# KENWOOD

ASB-1052

## Service Bulletin

**Subject:** TS-950SD 18.115 MHz Spur

### IF Unit (X48-3060-00) Foil Side View

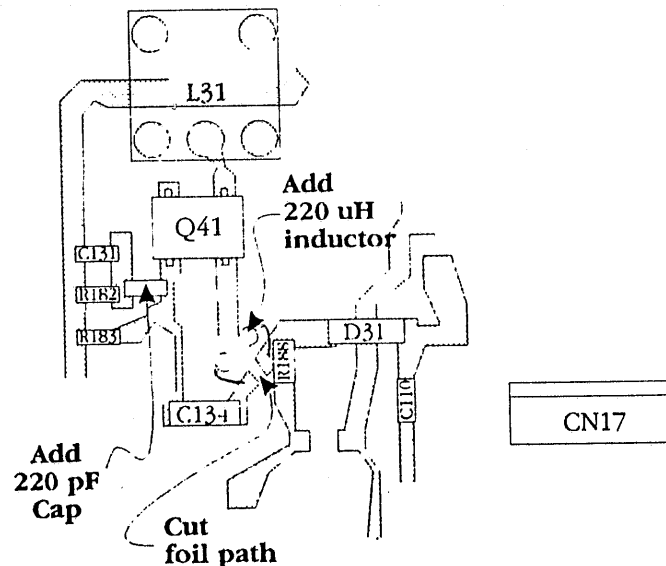
Transmitting on 18.1145 MHz causes a spur to appear at 18.1150 MHz with the antenna tuner on.

Add the low pass filter shown in the accompanying diagram to the input circuit of mixer Q41 on the IF Unit (X48-3060-00). This filter will increase the attenuation by approximately 20 dB.

Qty	Description	New Part No.	Circuit Description
1	220 uH Inductor	L40-2211-14	NA
1	220 pF Chip Capacitor	CC73FSL1H221J	NA
